Technical Service Bulletin: TSB190118

Jumper Harness for Lead-Free Transition of Ambient Air Pressure (AAP) Sensor

Figure 1, Current Scenario

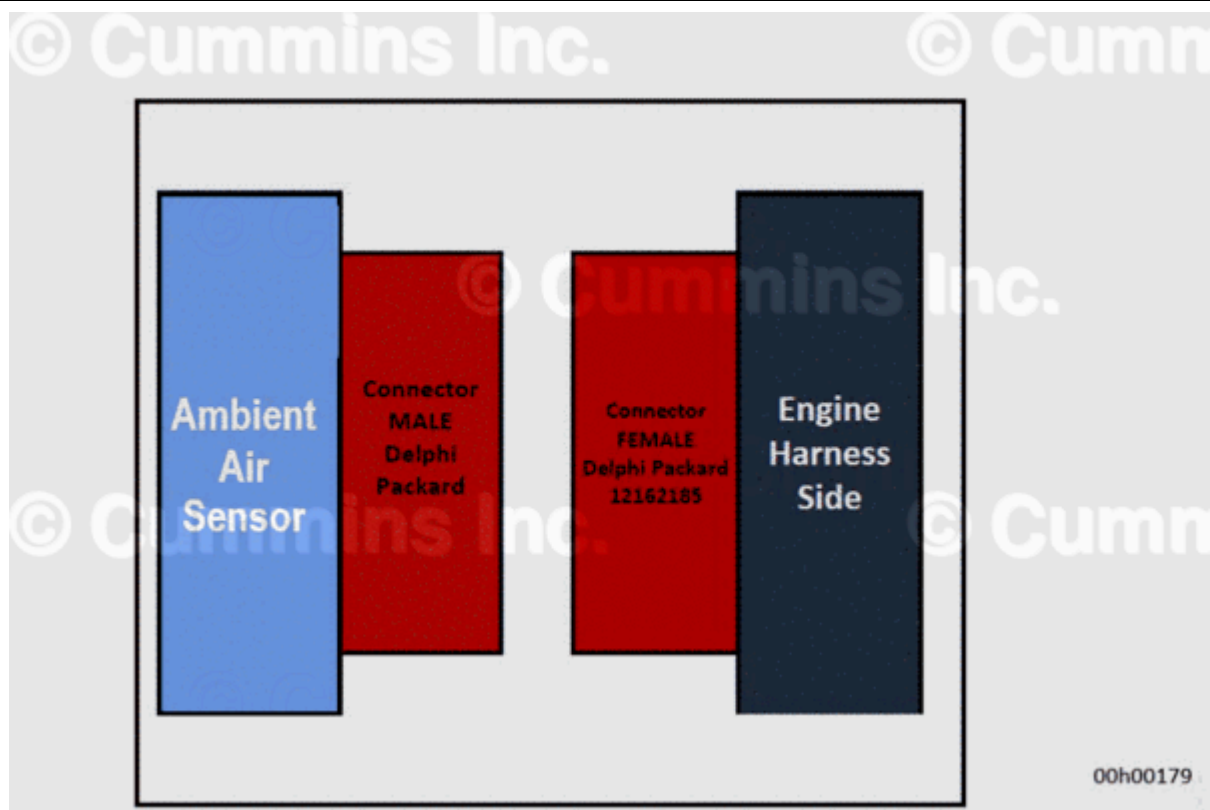
Due to the Cummins lead-free transition, leaded Ambient Air Pressure (AAP) sensors have been replaced by lead-free AAP sensors. The changes in some early sensor designs results in a difference in connector.

Figure 2, Proposed Solution

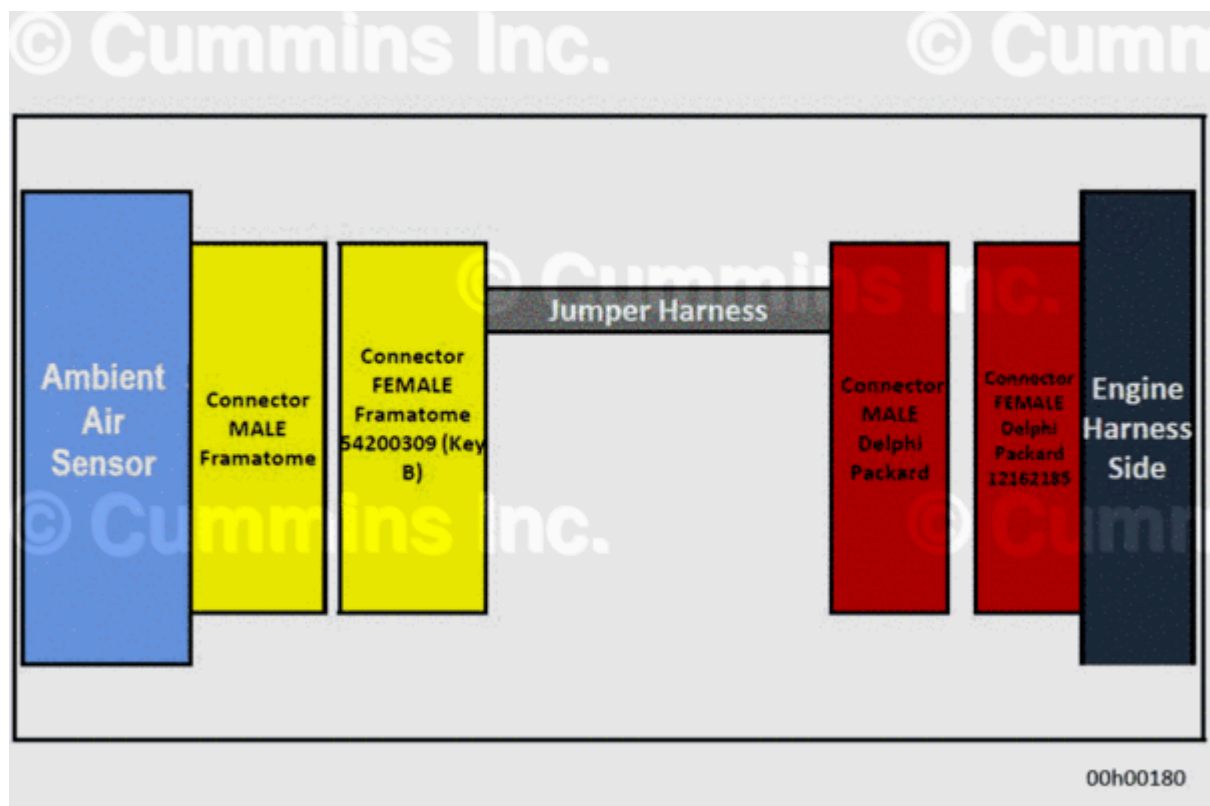
The jumper harness listed in Table 1 will allow customers using the existing harness listed in Table 1 to use the new AAP sensor.

Use the correct Ambient Air Pressure sensor. If applicable, install jumper harness. Some engine wire harnesses require the jumper harness to match the sensor connector. Using the incorrect replacement Ambient Air Pressure Sensor can cause engine shutdowns or derates with no associated fault codes.
